December 9, 2020

I've put this letter together at your request, as a written response from UFA addressing the decision by the Planning Commission in denying approval on the MDP for Scenic Mountain, Phase C. Let me start by saying I have had several phone and email exchanges with Julie Smith of Fieldstone Homes on this project beginning back at the concept phase. During these exchanges, I worked with her on conceptual site revisions and provided a list of changes I needed to see on the civil drawings to meet the fire code requirements. Each of the issues we discussed were addressed by Julie and her team.

# UNIFIED FIRE AUTHORITY

*FIRE PREVENTION DIVISION*

**38' ROW-(HURSTBOURNE DRIVE W/PARALLEL PARKING)**

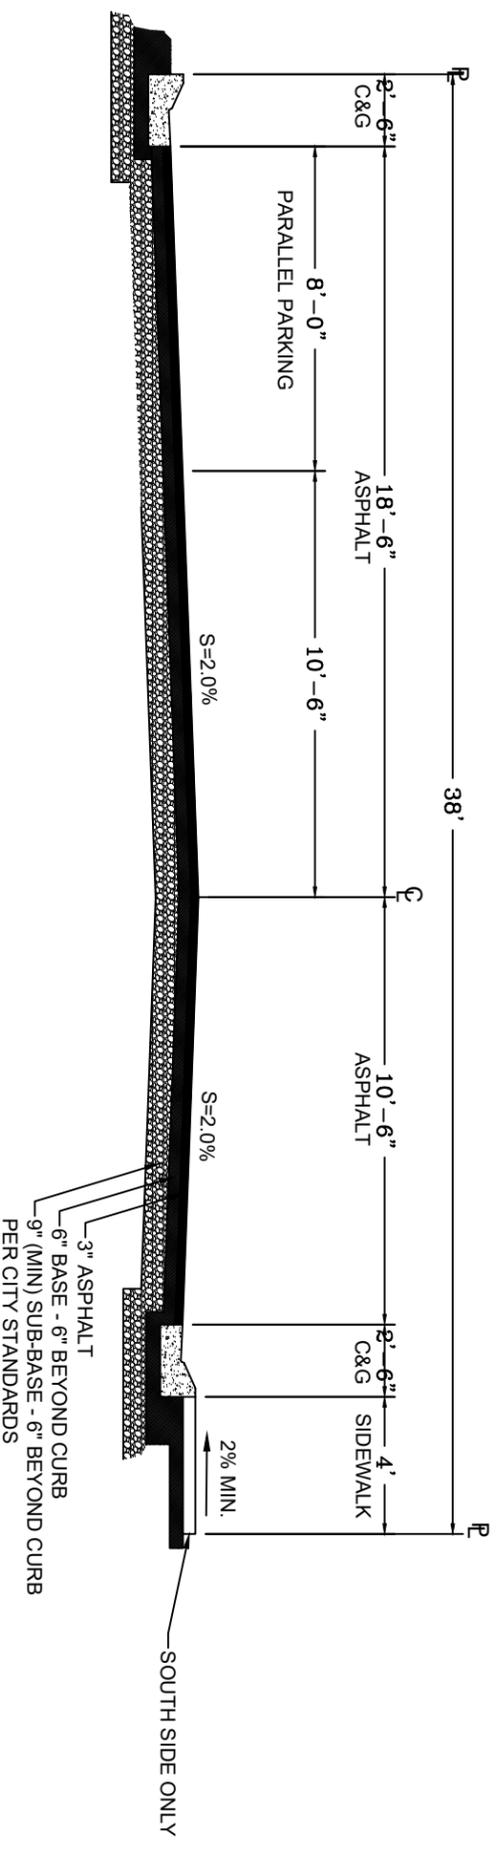
***Hurstbourne Drive Street Width / Parallel Parking*** – There is some confusion on the true width of Hurstbourne Drive due to an incorrect road cross-section being shown on the plans. The ROW for Hurstbourne Drive provides a total of 38' (see the attached update road cross-section). This provides the fire department with 34' of drivable surface. The fire code does not differentiate between public roads and private roads or private parallel parking spots and public curbside parking spots. If a residential roadway exceeds 32' in width, vehicles are allowed to park on both sides of the roadway while still maintaining fire department access. There has never been a requirement for parking restrictions along the full length of Hurstbourne Drive. The only portion of Hurstbourne Drive that requires restrictions is on the NE end at the S-turn where the road narrows down to connect to the existing Saratoga City roadway. By contrast, Vernham Lane is a full width residential road that allows for parking on both sides, yet the PC didn't raise any of the same safety concerns with this road. The 34' road width of Hurstbourne Drive is wider than the typical 32' road width provided in the standard 51' residential ROW currently being approved in the city.

The issue that kept coming up time and time again during the meeting was the lack emergency access on Hurstbourne Drive. Everyone seemed to be hung up with the parallel parking on the north side of the road. It was mentioned that there should be enough access width so fire apparatus had the ability to pass each other during an emergency. That is unrealistic. The city would need to increase the current residential road standard from 32' to 46' in width to accommodate that. The currently adopted residential road standards meet fire code. Hurstbourne Drive not only meets fire code, it exceeds it by 2'. There is not an access issue on Hurstbourne Drive.
